APPLICATION NUMBER: 25/0741

PROPOSAL: CONSTRUCTION OF STABLE BLOCK, ALTERATIONS TO ACCESS AND ECOLOGICAL ENHANCEMENTS

SITE: Land north of and adjacent to St Mary's Church, Church Lane
Marshfield Cardiff

FURTHER INFORMATION REQUIRED

Streetview 2023 looking north showing open views following hedge removal

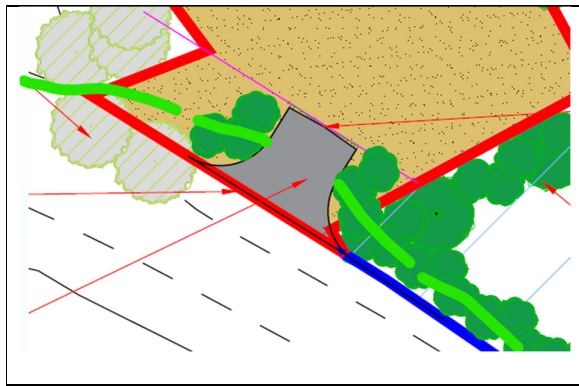
The site is in full view of users of Church Lane following removal of the road frontage hedge by previous owners, a native hedgerow separates the site from PROW ref **399/36/1**.

Where seen from Church Lane looking north, stables will be seen against a green backdrop but will be open to views alongside the site where parked vehicles in particular will be in full view as parking is not defined.
